**CLARKE COUNTY PLANNING COMMISSION
TABLE OF CONTENTS
October 3, 2017 Briefing Meeting
October 6, 2017 Regular Meeting**

**SPECIAL USE PERMIT/SITE PLAN (SUP-17-03/SP-17-01)
Clarke County Board of Supervisors (Citizens' Convenience Center)
October 6, 2017 Planning Commission Meeting – CONTINUED PUBLIC HEARING
SUPPLEMENTARY STAFF REPORT #1 – Department of Planning**

CLARKE COUNTY CITIZEN CONVENIENCE CENTER CLARKE COUNTY, VIRGINIA

SHEET NO.
KARST

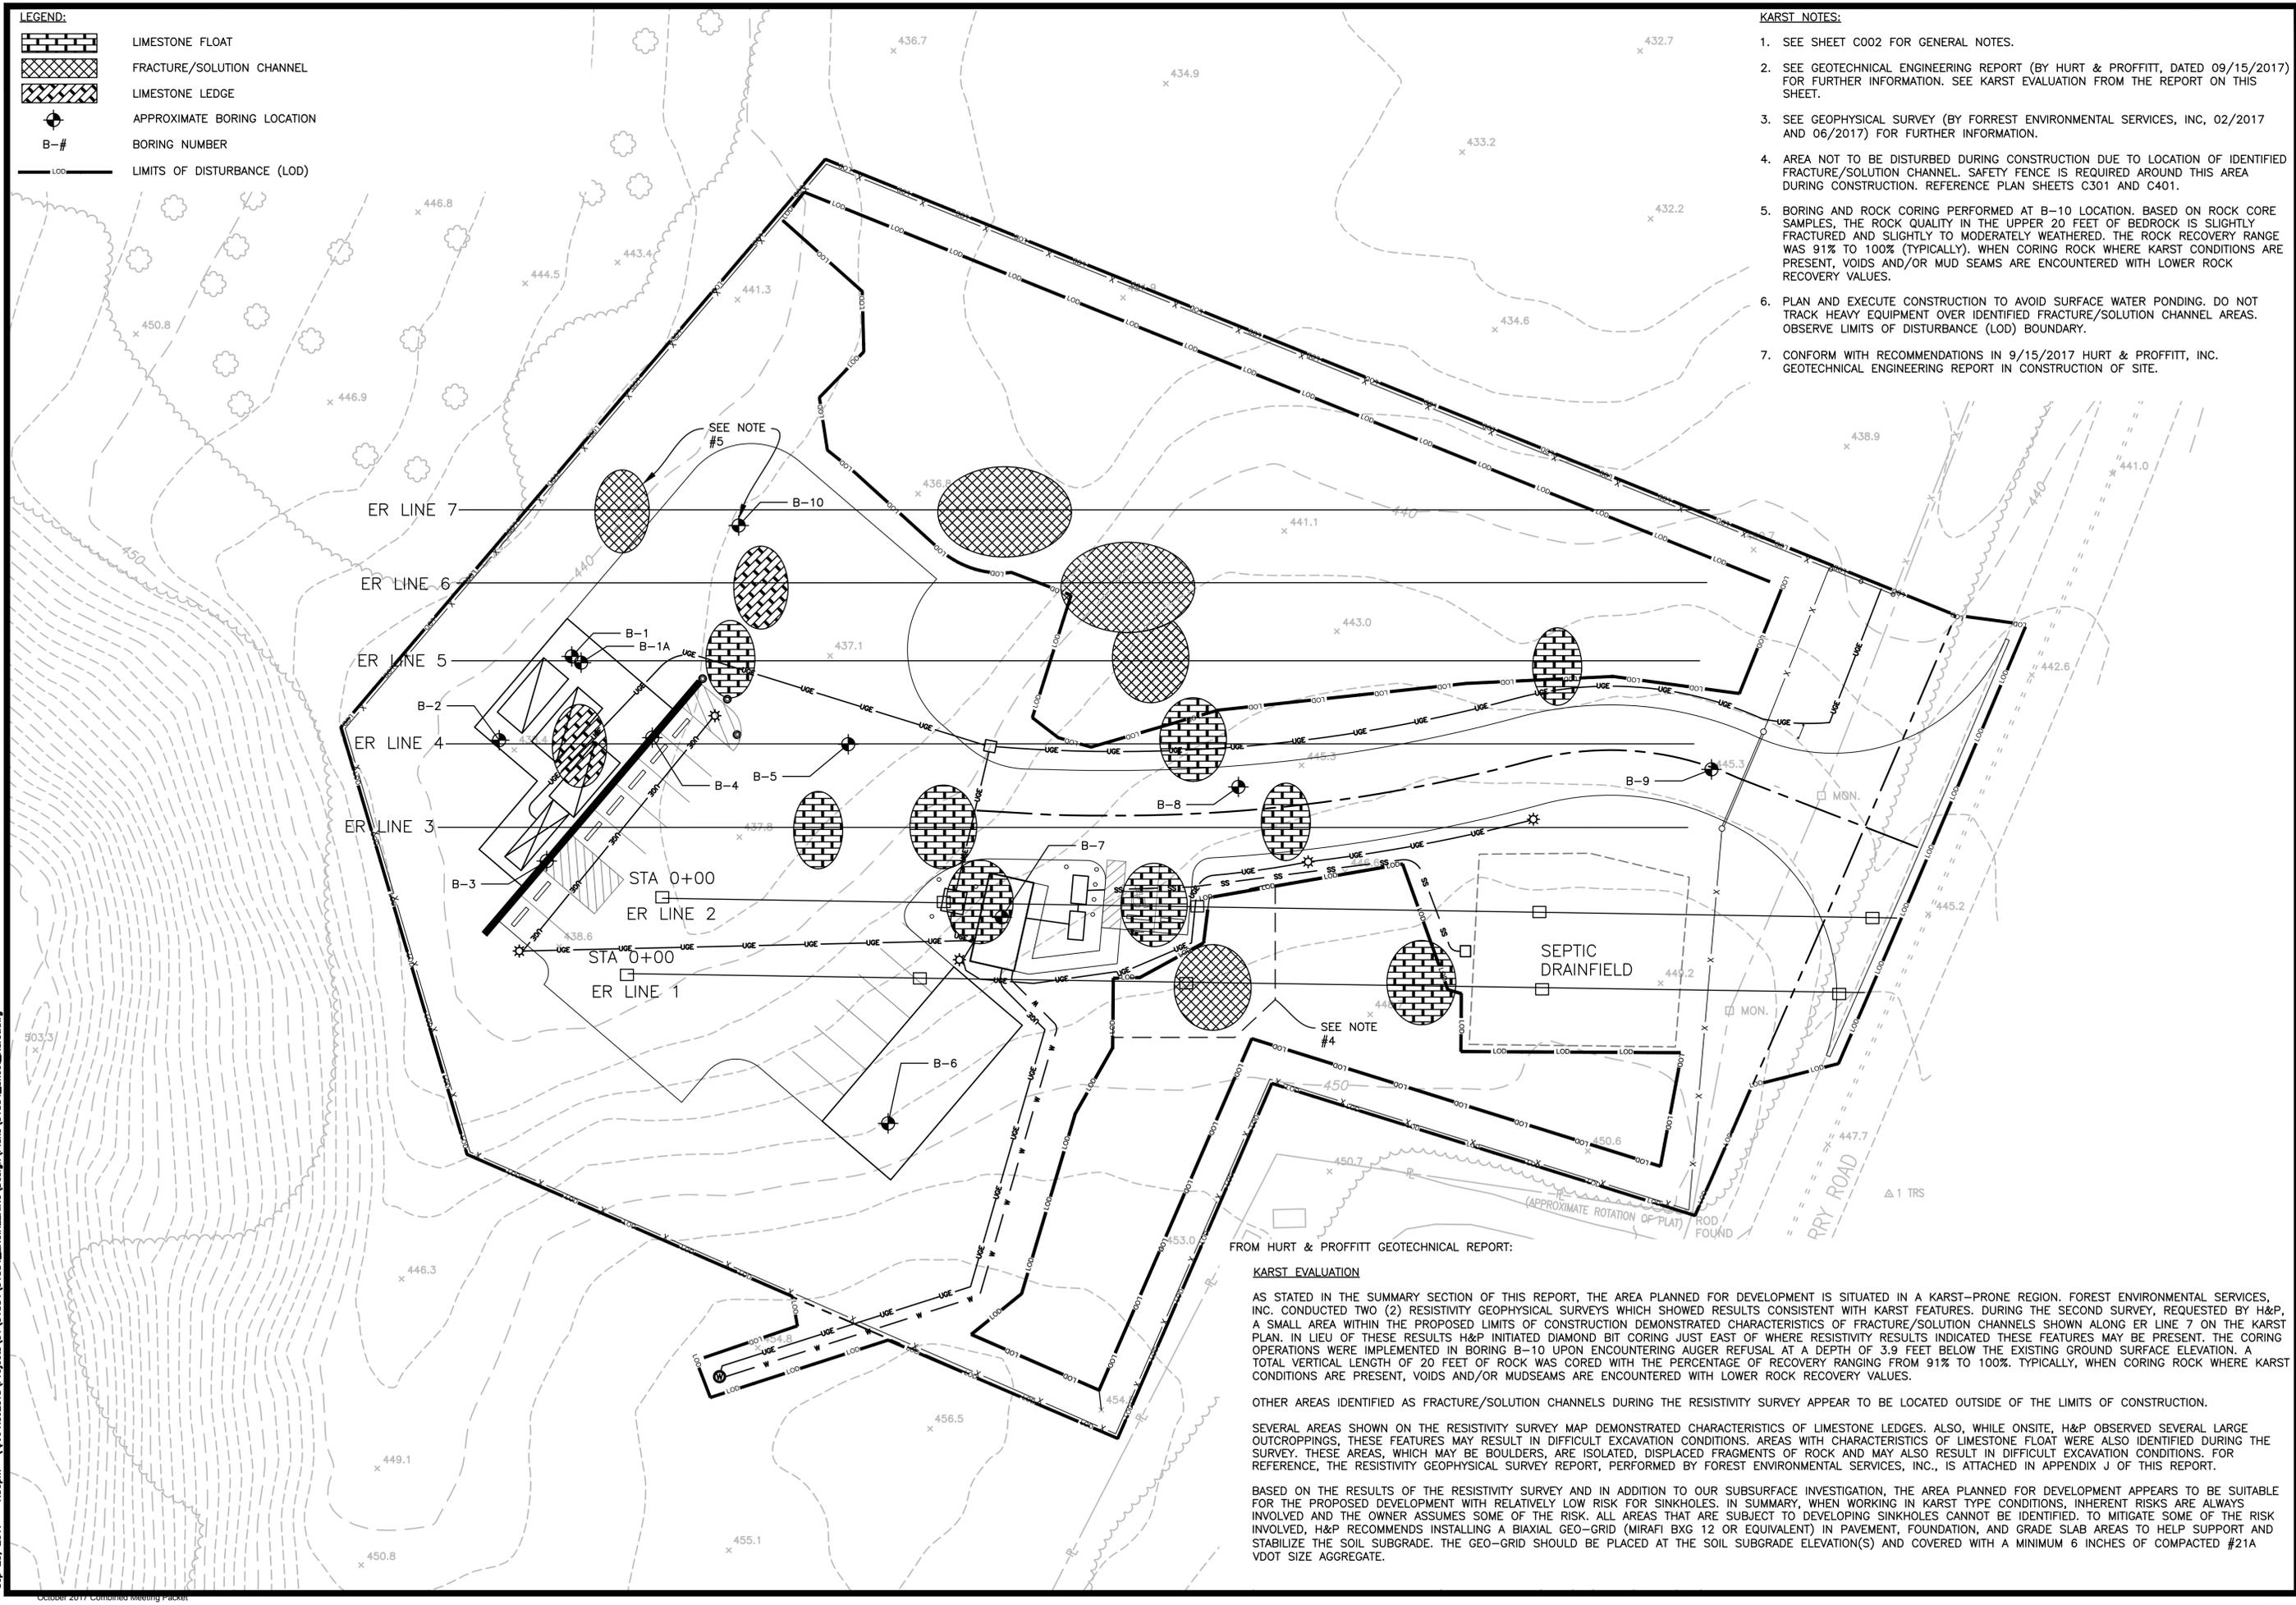
On September 21, 2017, Staff received an email from Dan Rom, County Karst Engineering Consultant, that stated, “In summary, the Karst Plan reported by H&P generally conforms to industry standards; however, additional comment regarding the adequacy of cement grout as a borehole filler should be provided.” Earlier in the report Mr. Rom noted, “H&P noted, on page 3 of the geotechnical report, that borings were backfilled using cement grout in the upper one-half to one-third of depth. Straight cement grout is subject to shrinkage and may not provide an adequate long-term seal and protection from infiltration. Generally, a cement-bentonite grout is used. It is recommended that H&P provide additional discussion.”

Therefore, in terms of the overall Karst review of the project the County karst consultant has approved the study, but a grouting issue is being discussed between the engineers. This is not a substantive impact to the SUP/SP review. The Applicant’s engineer responded to this concern by email on September 27, 2017, and we are awaiting Mr. Rom’s reply.
